US DEPARTMENT OF ENERGY
HANFORD WASTE VITRIFICATION PLANT

DESIGN CHANGE NOTICE

DCN - 0084

DCN TITLE
INCREASED MELTER
CAPACITY CDC CANISTER
STORAGE RACK

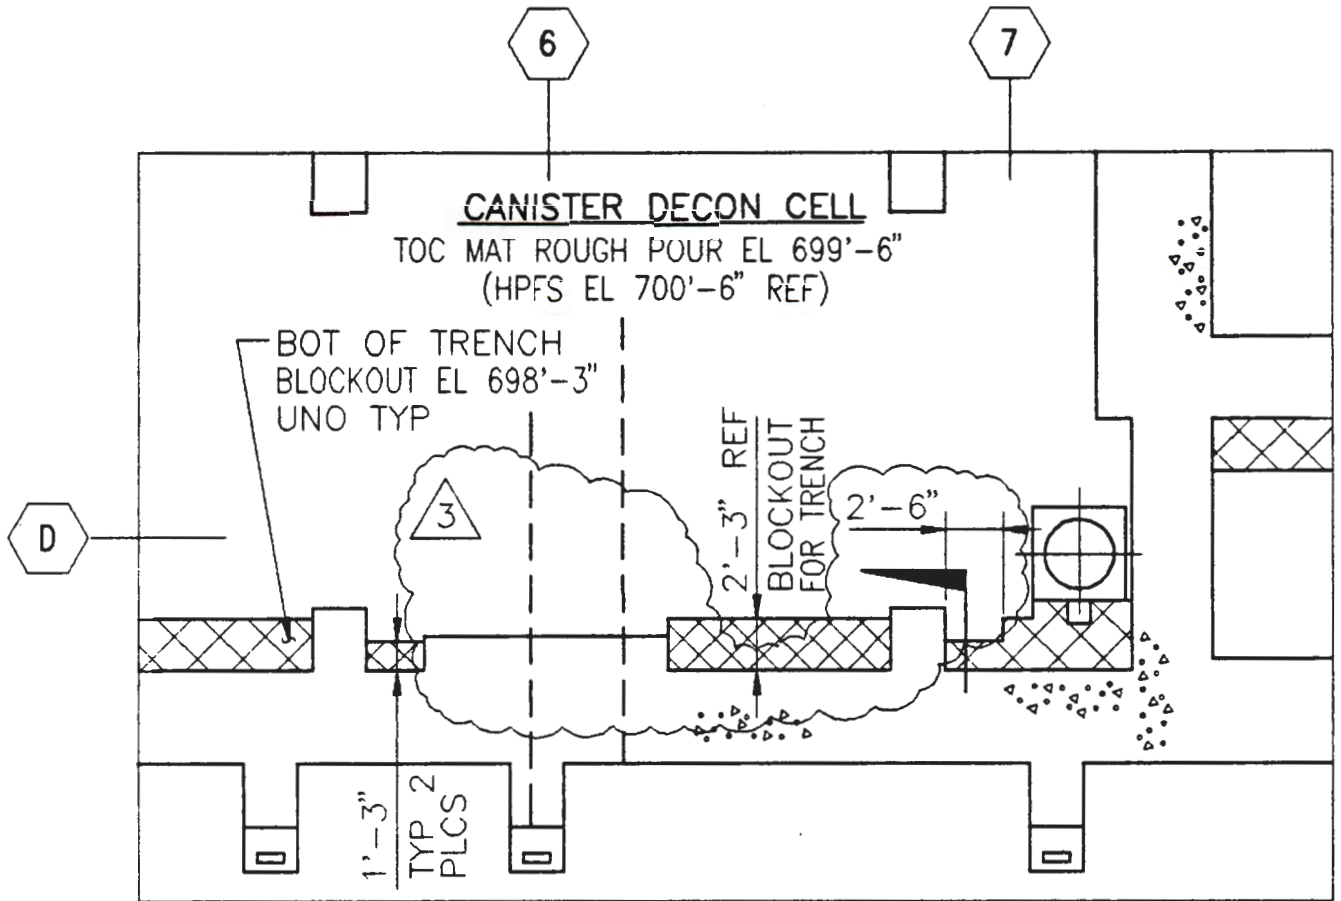
FLUOR DANIEL		U.S. DEPARTMENT OF ENERGY HANFORD WASTE VITRIFICATION PLANT		DESIGN CHANGE NOTICE	
DESCRIPTION OF CHANGE: INCREASED WIDTH OF PILASTER FOR THE REVISED DIRTY CANISTER STORAGE RACK				BASE DOC. NO. H-2-117431 SHT/PG. 1 REV. 2 CR NO. CR-HWVP-1037 (D2)	
				DISCIPLINE: STRUCTURAL	
PREPARED BY: E. AGCAOILI/ A. IZURIETA		DATE: 08/05/93		DCN - 0084	
DISCIPLINE ENGINEER: E. JORGENSEN		DATE: 08/27/93

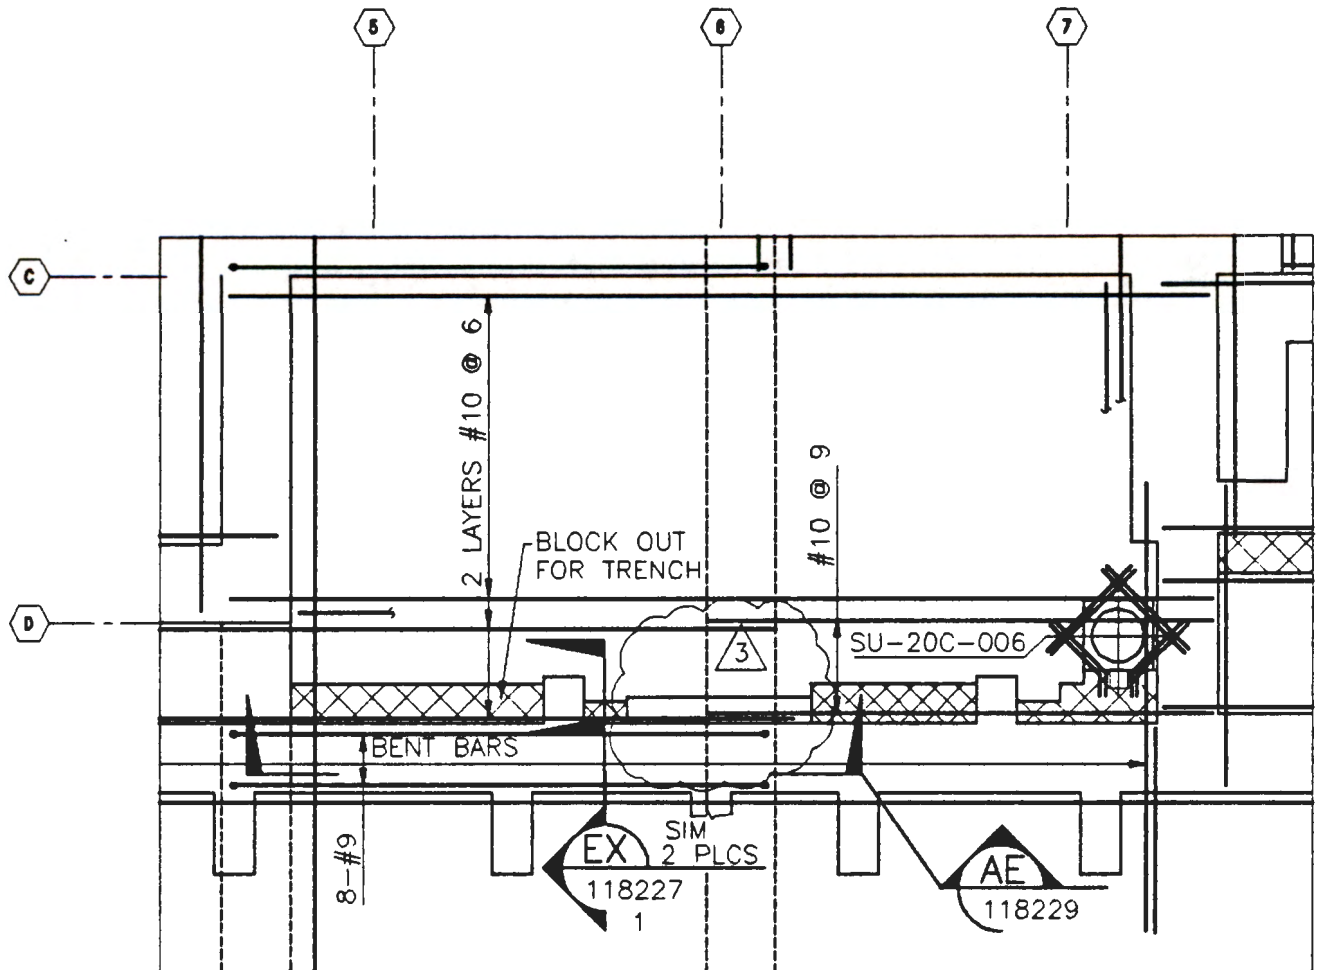
FLUOR DANIEL		U.S. DEPARTMENT OF ENERGY HANFORD WASTE VITRIFICATION PLANT		DESIGN CHANGE NOTICE	
DESCRIPTION OF CHANGE: INCREASED WIDTH OF PILASTER FOR THE REVISED DIRTY CANISTER STORAGE RACK				BASE DOC. NO. H-2-117437 SHT/PG. 1 REV. 2 CR NO. CR-HWVP-1037 (D2) DISCIPLINE: STRUCTURAL	
PREPARED BY: E. AGCAOILI/ A. IZURIETA		DATE: 08/05/93		DCN - 0084	
DISCIPLINE ENGINEER: E. JORGENSEN		DATE: 08/27/93

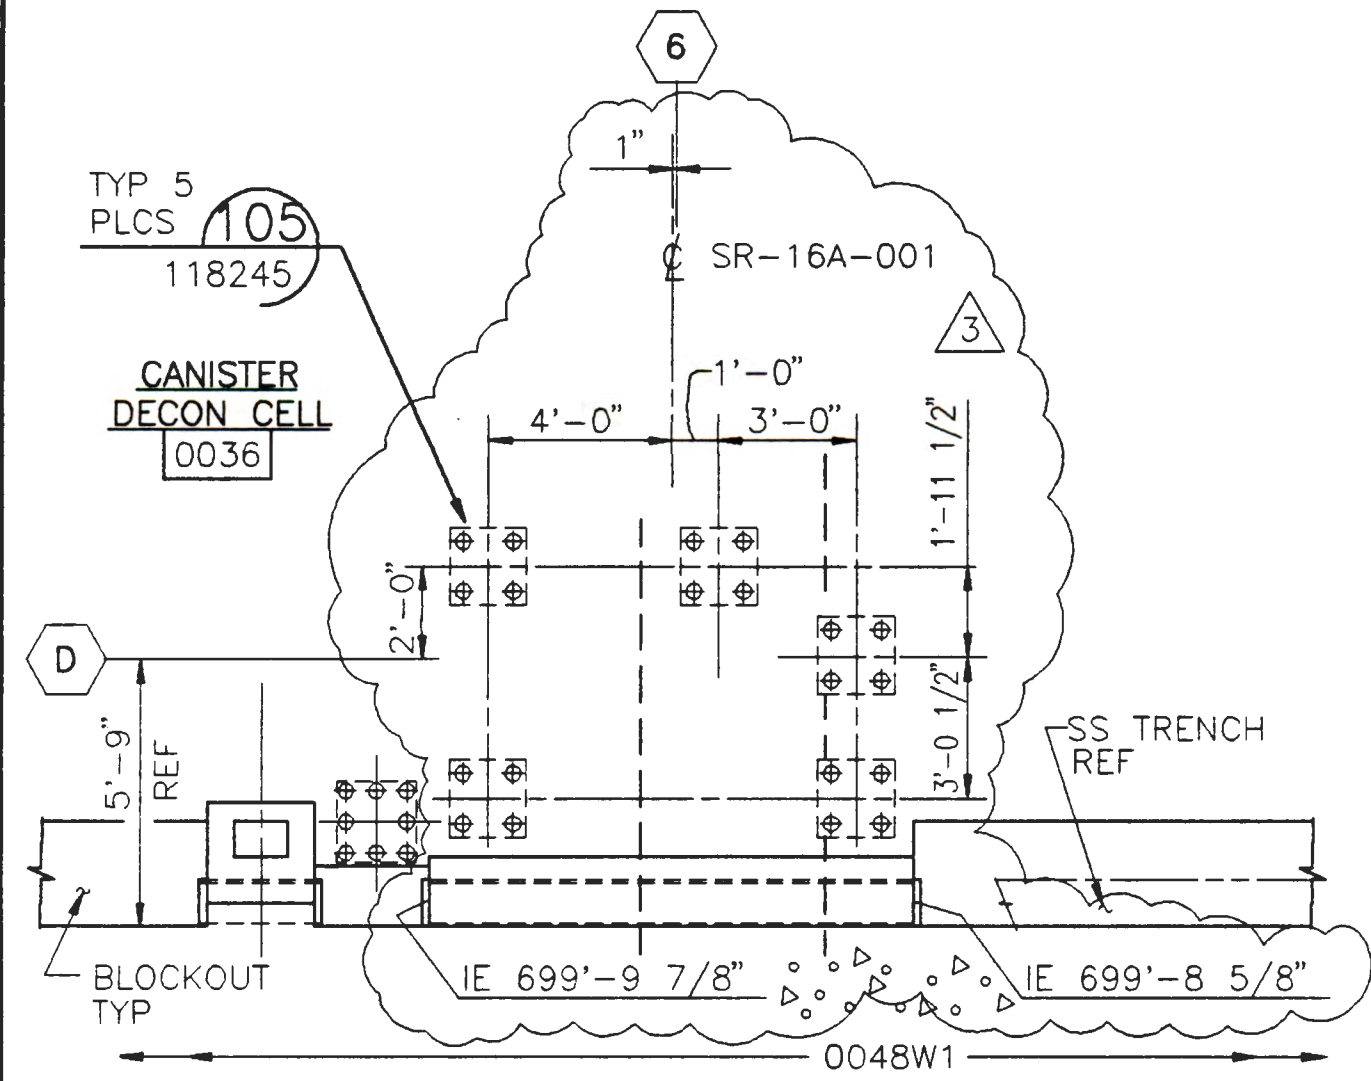
FLUOR DANIEL		U.S. DEPARTMENT OF ENERGY HANFORD WASTE VITRIFICATION PLANT		DESIGN CHANGE NOTICE	
DESCRIPTION OF CHANGE: RELOCATED ANCHOR SUPPORTS FOR THE REVISED DIRTY CANISTER STORAGE RACK				BASE DOC. NO. H-2-117445 SHT/PG. 1 REV. 2 CR NO. CR-HWVP-1037 (D2)	
				DISCIPLINE: STRUCTURAL	
PREPARED BY: E. AGCAOILI/A. IZURIETA		DATE: 07/30/93		DCN - 0084	
DISCIPLINE ENGINEER: E. JORGENSEN		DATE: 08/27/93		REV. 0 PAGE 5

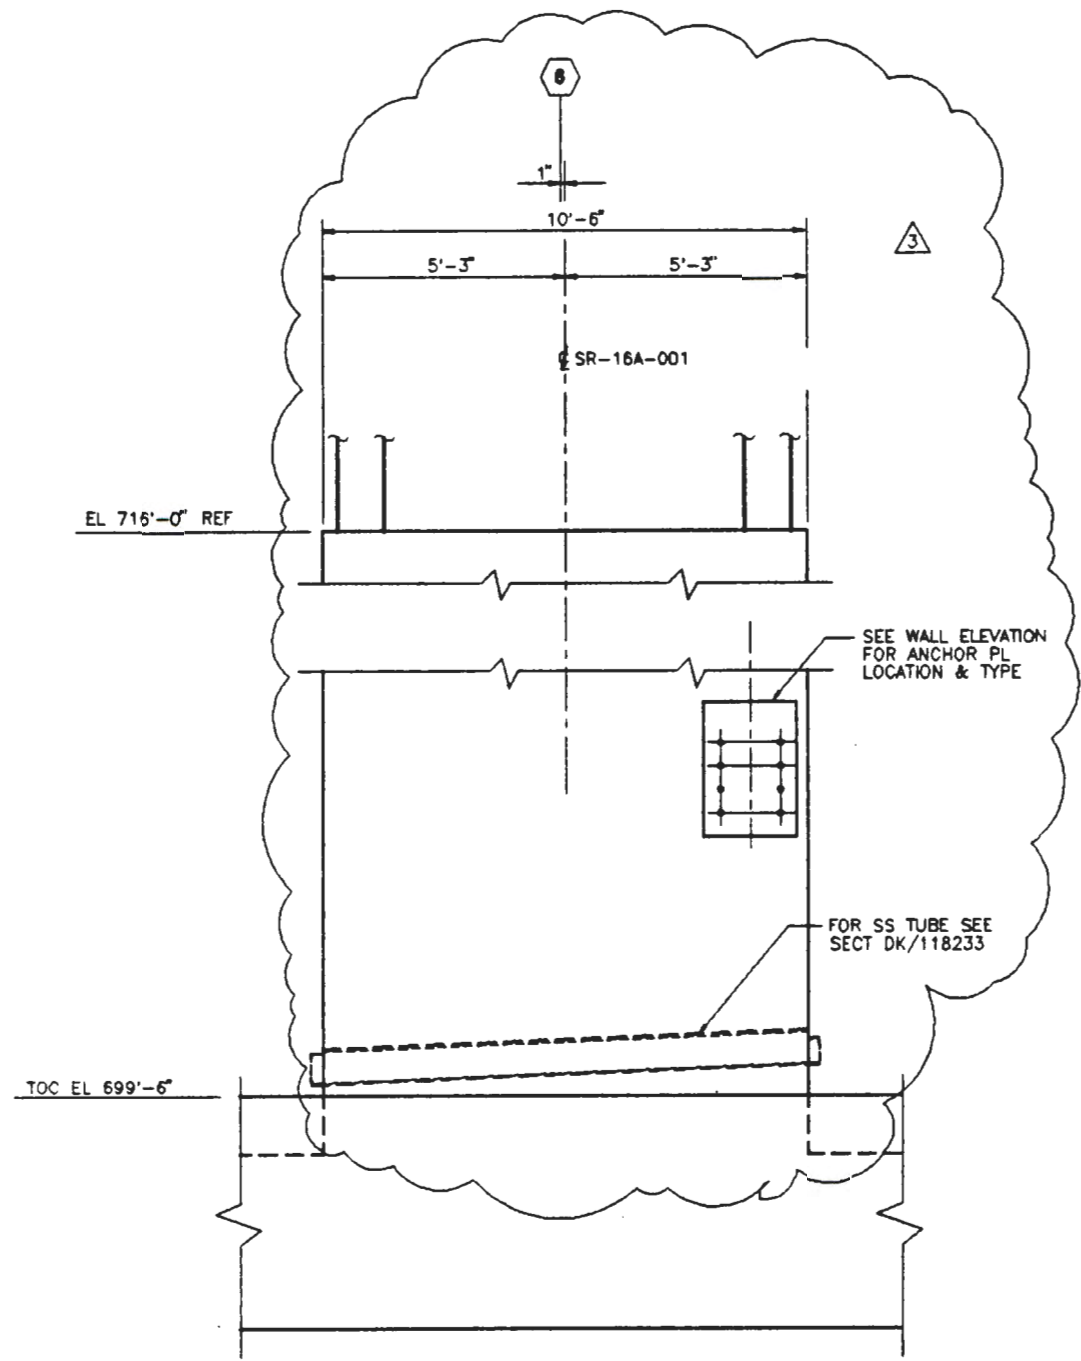
FLUOR DANIEL	U.S. DEPARTMENT OF ENERGY HANFORD WASTE VITRIFICATION PLANT		DESIGN CHANGE NOTICE			
	DESCRIPTION OF CHANGE: INCREASED WIDTH OF PILASTER AND RELOCATED ANCHOR PLATE FOR THE REVISED DIRTY CANISTER STORAGE RACK		BASE DOC. NO. H-2-118234 SHT/PG. 1 REV. 2 CR NO. CR-HWVP-1037 (D2)	DISCIPLINE: STRUCTURAL		
PREPARED BY: E. AGCAOILI/A. IZURIETA	DATE: 07/30/93	DISCIPLINE ENGINEER: E. JORGENSEN	DATE: 08/27/93	DCN - 0084	REV. 0	PAGE 6

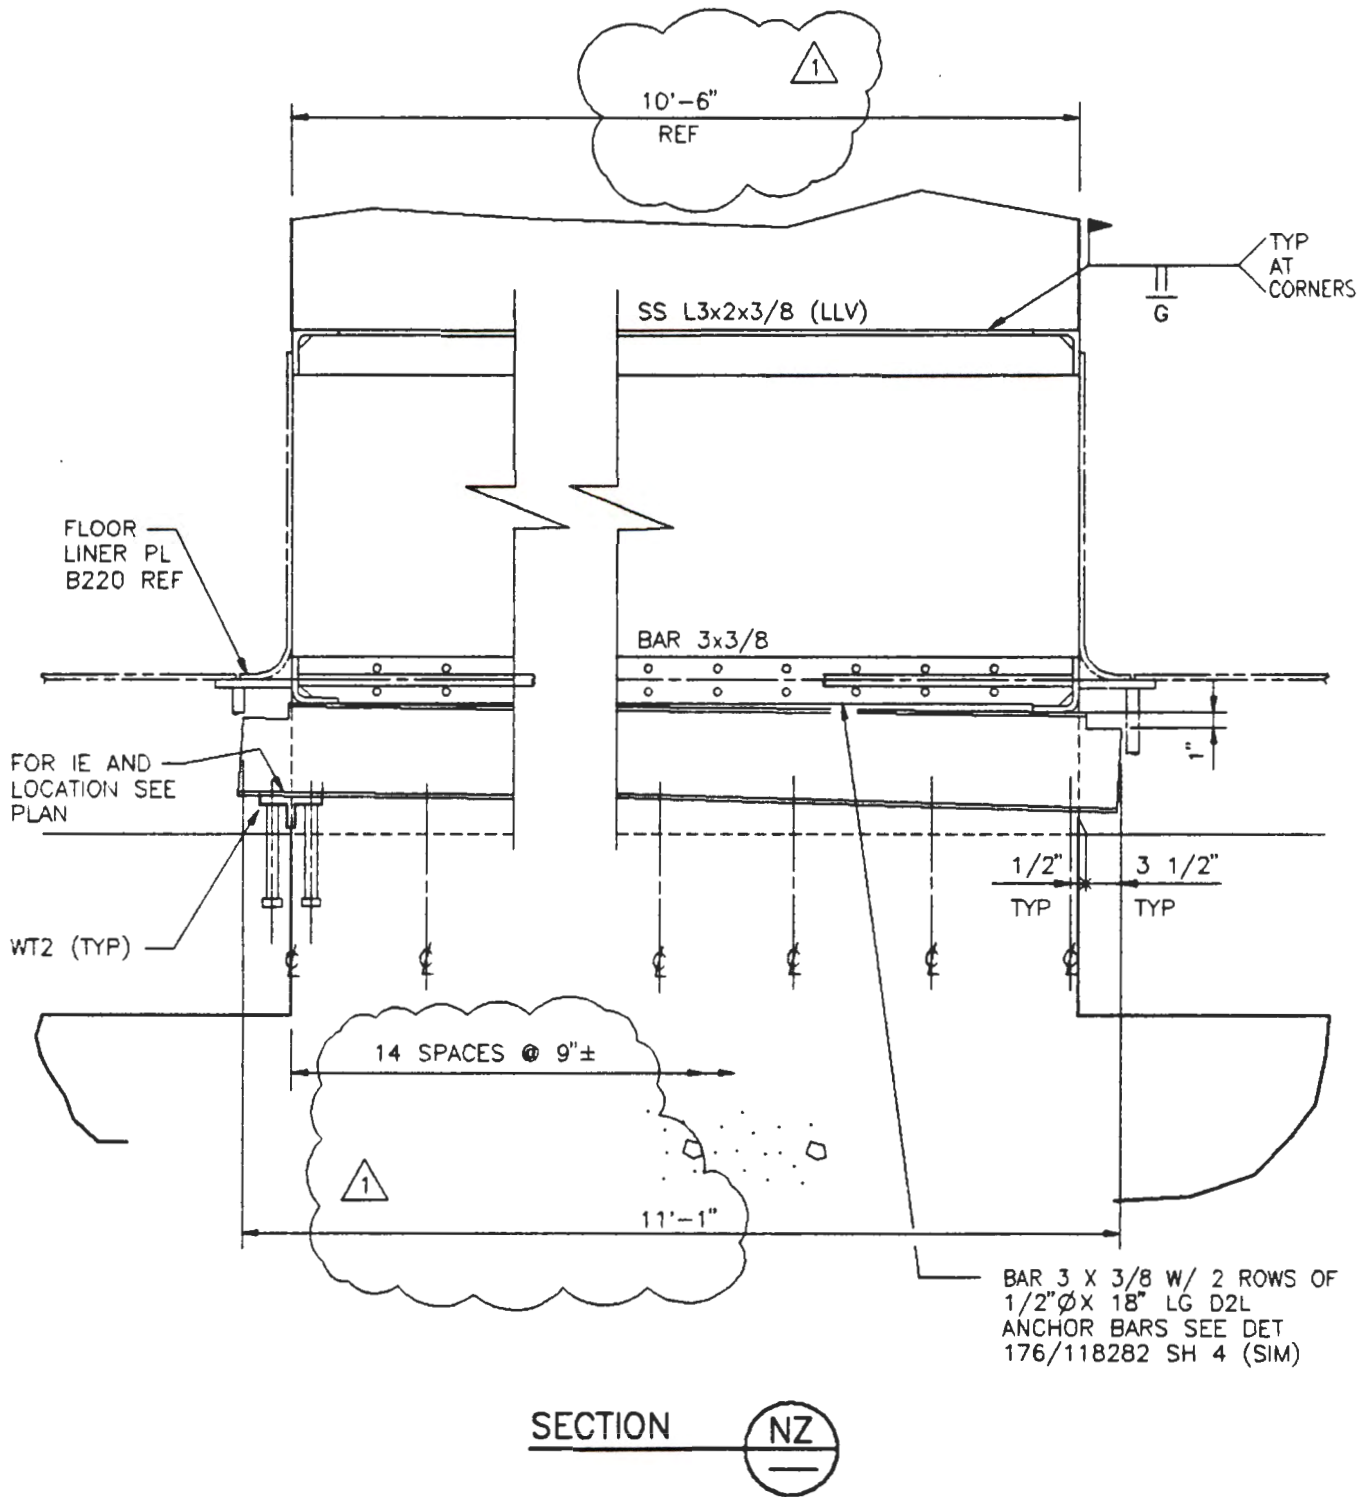
FLUOR DANIEL	U.S. DEPARTMENT OF ENERGY HANFORD WASTE VITRIFICATION PLANT	DESIGN CHANGE NOTICE		
DESCRIPTION OF CHANGE: INCREASED WIDTH OF PILASTER AND LENGTH OF SS TUBE FOR THE REVISED DIRTY CANISTER STORAGE RACK		BASE DOC. NO. H-2-118281 SHT/PG. 6 REV. 0 CR NO. CR-HWVP-1037 (D2) DISCIPLINE: STRUCTURAL		
PREPARED BY: E. AGCAOILI/A. IZURIETA	DATE: 08/03/93	DCN - 0084	REV. 0	PAGE 7
DISCIPLINE ENGINEER: E. JORGENSEN	DATE: 08/27/93
